2400
9.14m LOTS
GARDEN 3 (GR)
ELEVATION 1, 2 & 3
A1 PACKAGE
O.REG. 332/12

CITY OF CAMBRIDGE BUILDING DIVISION THESE PLANS have been examined for compliance with the Ontario Building Code Requirements. A Building Permit is in order to issue subject to any changes noted under the condition that the building will be constructed in accordance with the code Inspector: Thomas Weathers Date: 2023-03-08

TITLE SHEET	
BARLASSINA CONSTRUCTION CITY OF CAMBRIDGE

SIDE ELEVATION 3
BARLASSINA CONSTRUCTION
CITY OF CAMBRIDGE

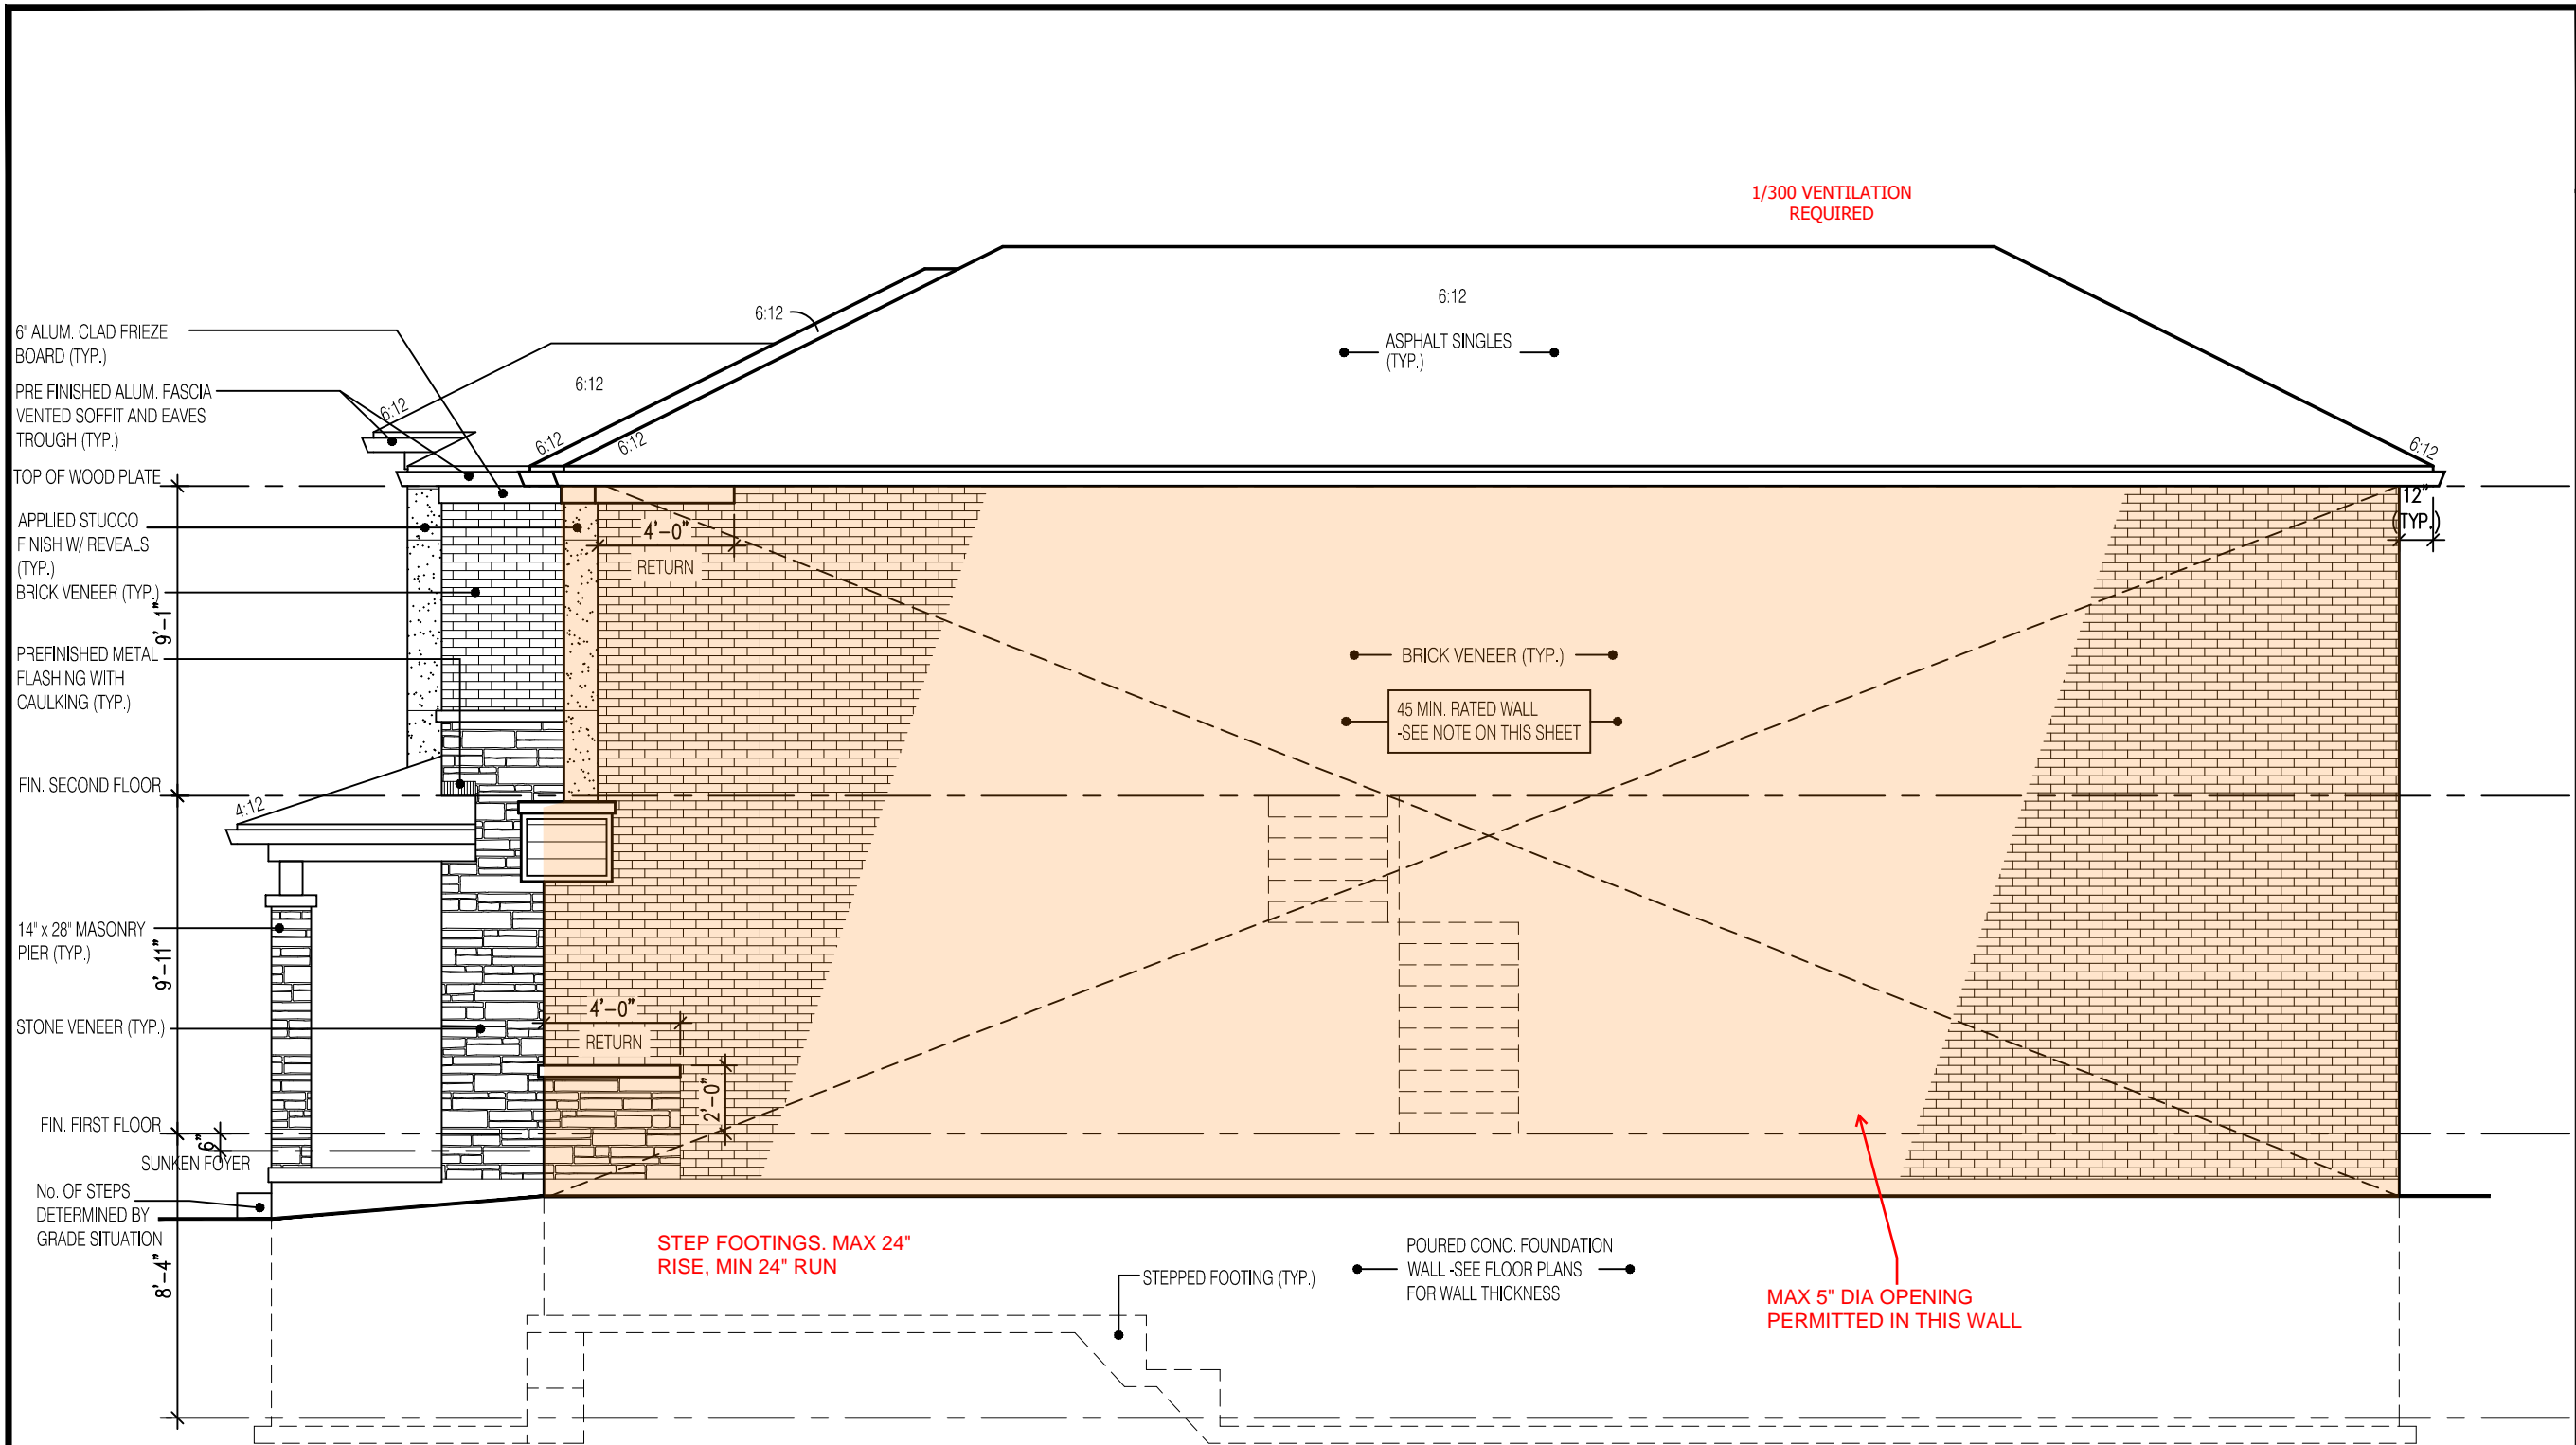
PROVIDE 15.9mm (5/8") TYPE "X" GYPSUM BOARD BETWEEN FLOOR JOIST AT THE HEADER OR CONTINUOUSLY ALONG THE RIM JOIST WHEN FLOOR JOISTS ARE PARALLEL TO RIM JOIST TO MAINTAIN

PROVIDE A CONTINUOUS LAYER 12.7mm (1/2") TYPE "X" GYPSUM BOARD (INTERIOR SIDE) INSTALLED SO THAT ALL EDGES ARE SUPPORTED, TAPED AND FILLED. SPACE BETWEEN WOOD STUDS TO BE FILLED WITH PREFORMED MINERAL FIBRE INSULATION WITH A MASS OF NOT LESS THAN 1.22 Kg/SQ.M. AND MUST FILL AT LEAST 90%% OF THE CAVITY THICKNESS. THE TYPE " X" & INSULATION MUST BE RUN CONTINUOUSLY BEHIND ALL INTERSECTING PARTIONS. MECHANICAL CHASES, BATHTUBS, SHOWERS, ETC. ENSURE INSULATION & TYPE "X" IS INSTALLED IN GARAGE EXTERIOR WALLS.
